PLANNING APPLICATION REF: 2022/62/92406/W - CHIPPINGS SITE, CHAPELGATE, SCHOLDS

Further to my previous comments of 5th September 2022 I wish to register my continued opposition to the above, my additional comments of objection being as follows:

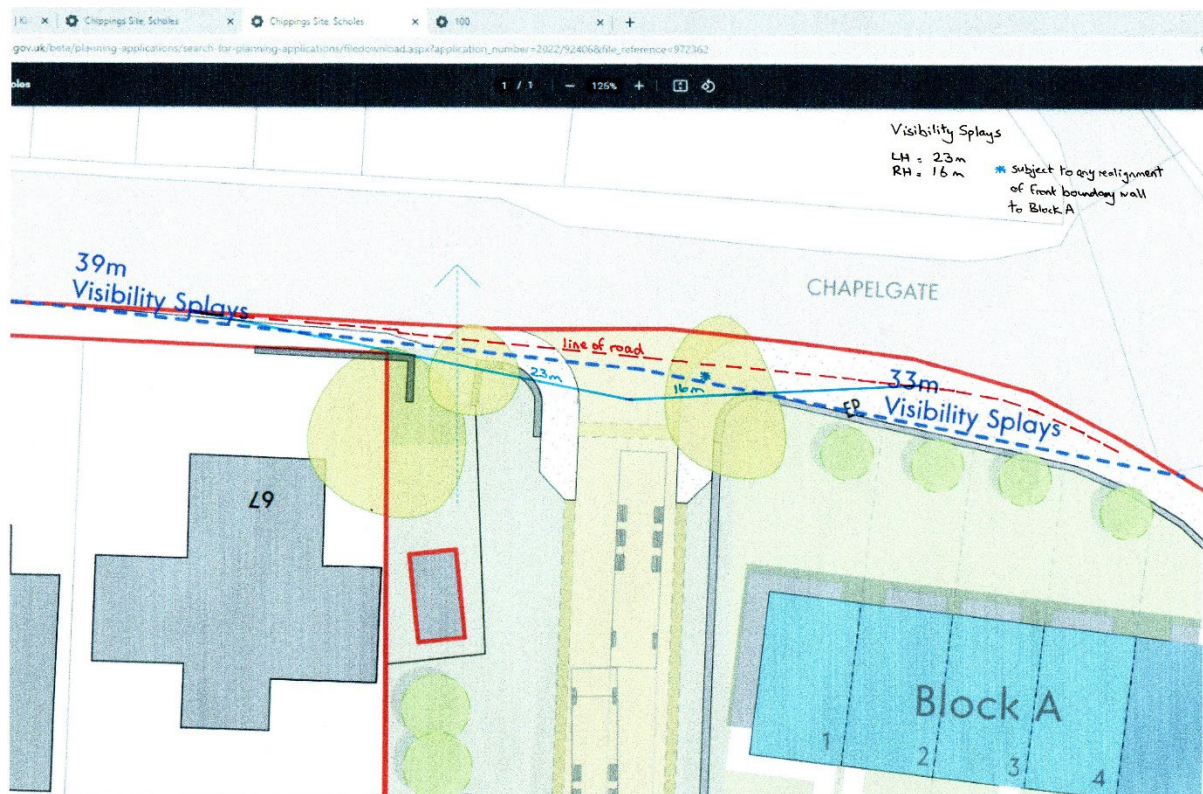
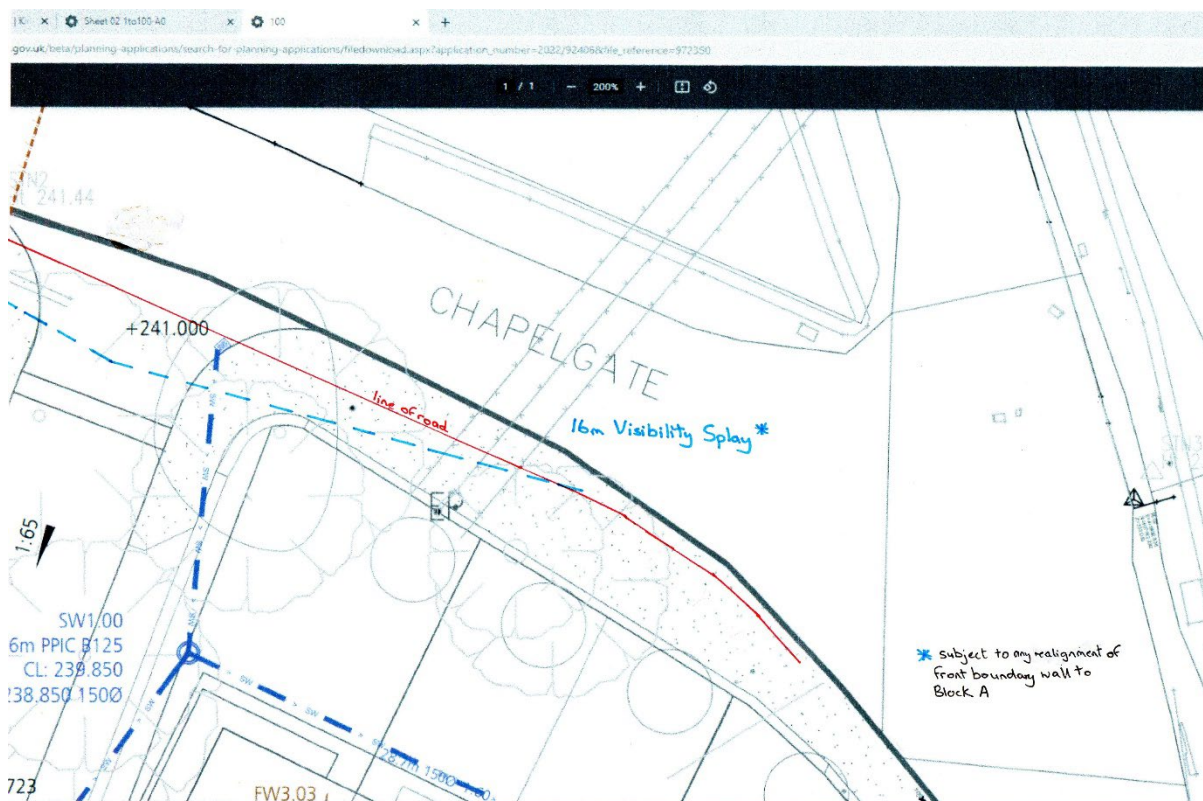
The plans below show what is now the actual edge of the road. You can physically see where pieces of stone have been used at the edge as a face to tarmac up to in the past. Section 44 of the Highways Act 1959, superseded by Section 41 of the Highways Act 1980 places a duty on the local highways authority to maintain the highway. A lack of maintenance has resulted in the verge encroaching onto the highway over the years. Consequently, the visibility splays shown on the Applicants block plan cannot meet the requirements of the Highways Design guide as the Applicant has relied on the line of the overgrown verge being the road in order to achieve the visibility splays shown. The copy of the block plan below shows what the visibility splays actually are. The larger scale plans show the LH splay being 23m and the RH splay being 16m subject to possible change.

It should be noted that the left-hand visibility splay cannot be altered. These visibility splays do not meet with the requirements of the Highways Design Guide.

HIGHWAYS – the visibility splays shown are incorrect as the Applicant has based them on the incorrect line (edge) of the road together with parts of the highway to provide visibility splays needed to meet the requirements of the Highways Design Guide. The revised visibility splays shown using the correct line of road edge **do not conform** with these requirements.
